FOR PLANNING

This document shows the differences between the superceded site plan and the new site plan. It is to be read in conjunction with all other submitted documents.

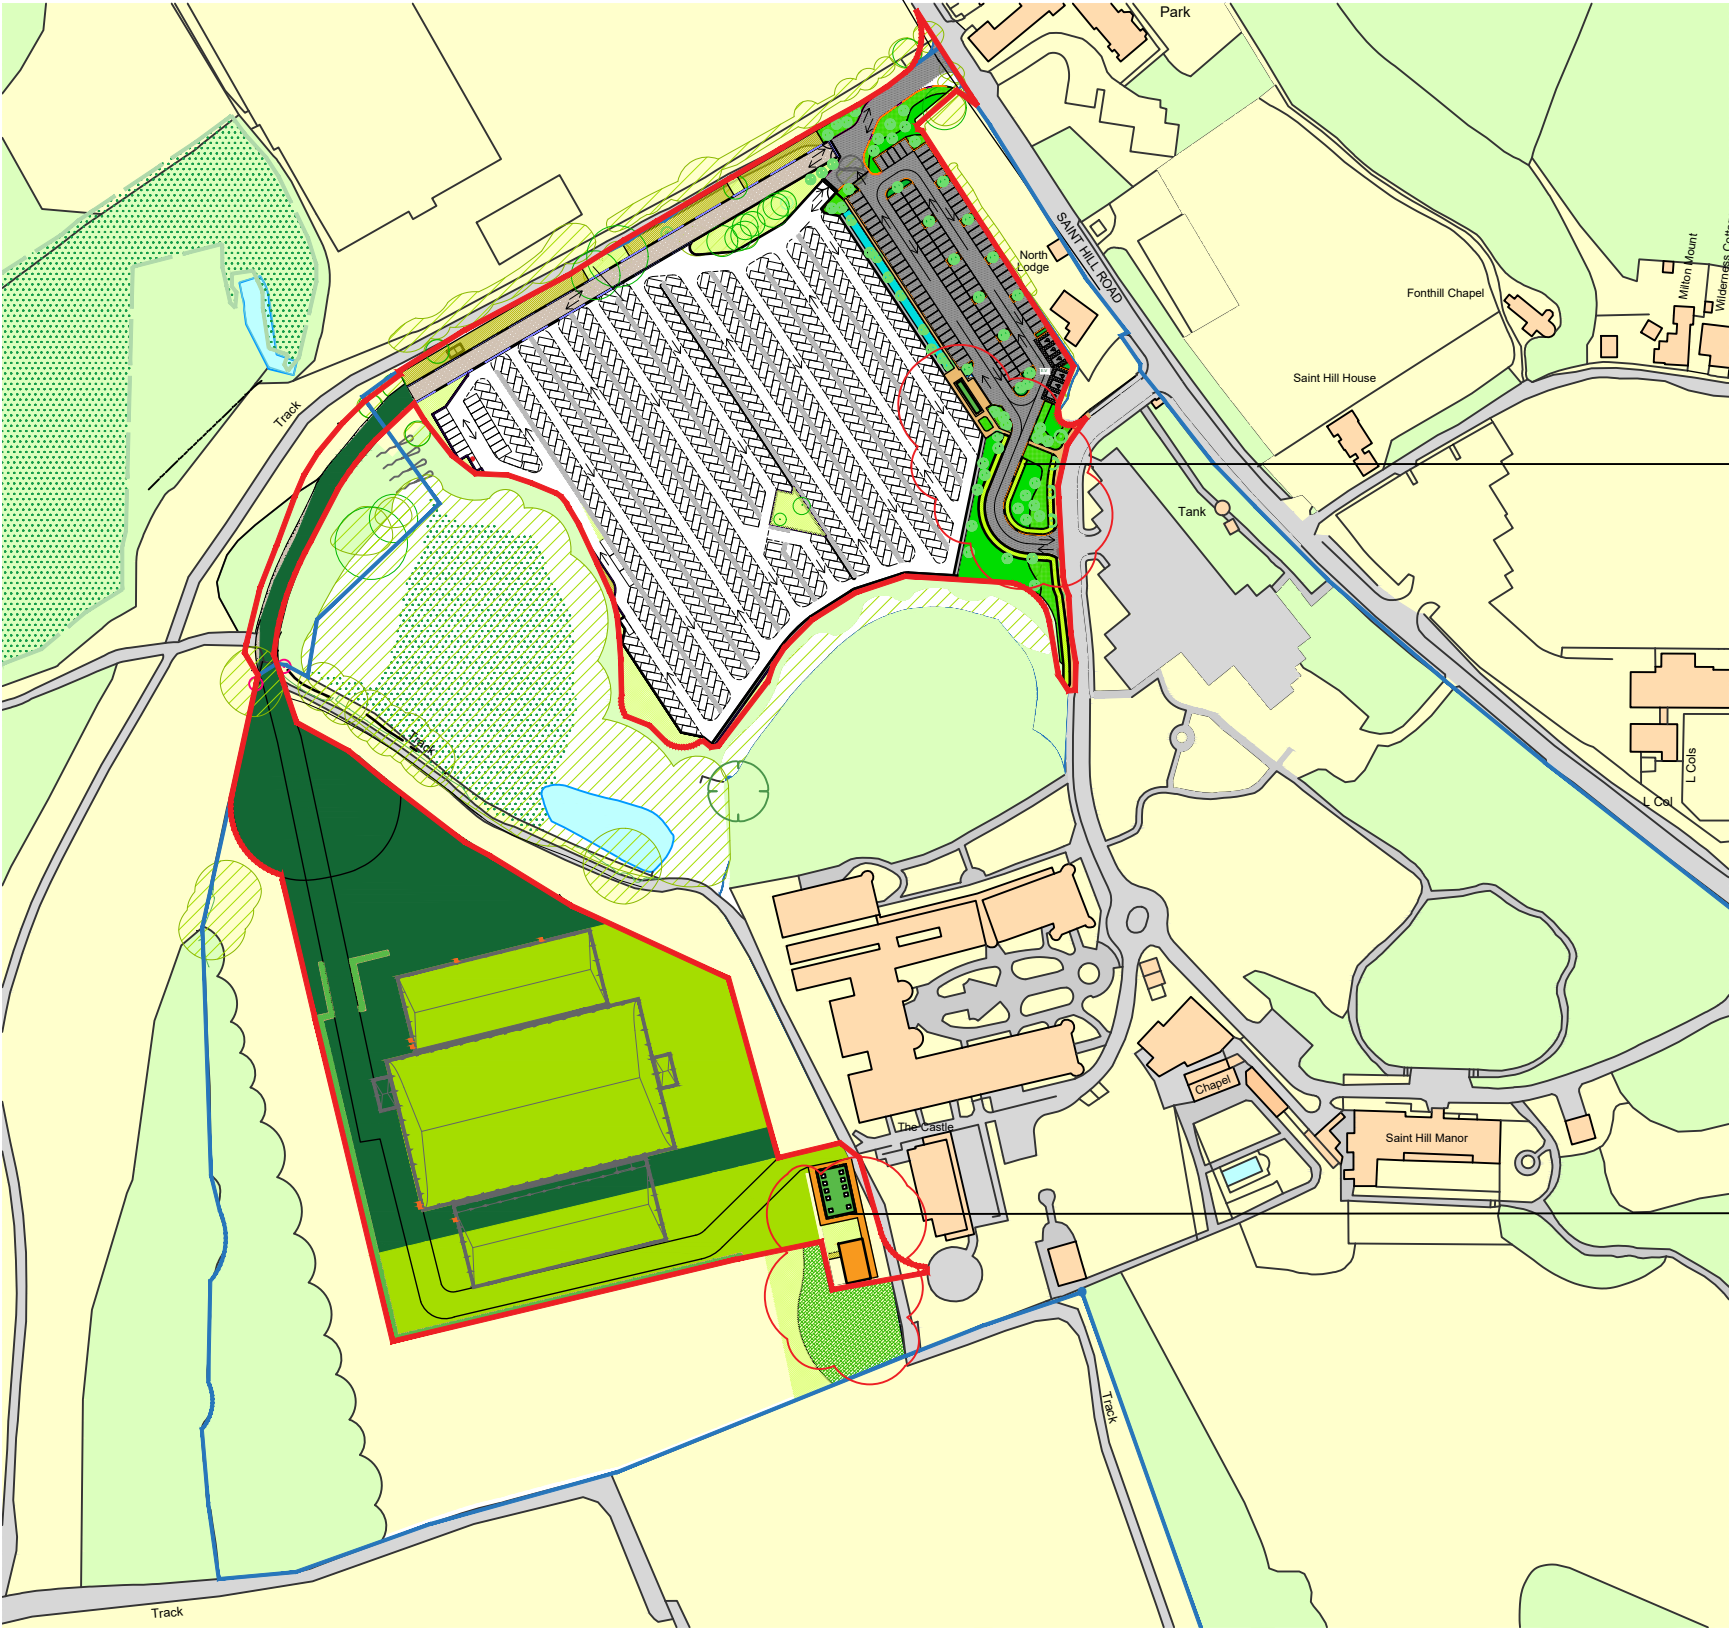
Entrance to car park has been modified to reduce visual impact to Saint Hill Road

Waiting area replaces previous washroom in car park to reduce impact of development on Jurhing Field. The waiting area now features masonry external structure to match St. Hill Manor and the neighboring garage.

Washroom adjacent to refectory has been reduced in size and is surrounded by BNG enhancement reducing visual impact of this development. The washroom now features masonry external structure.
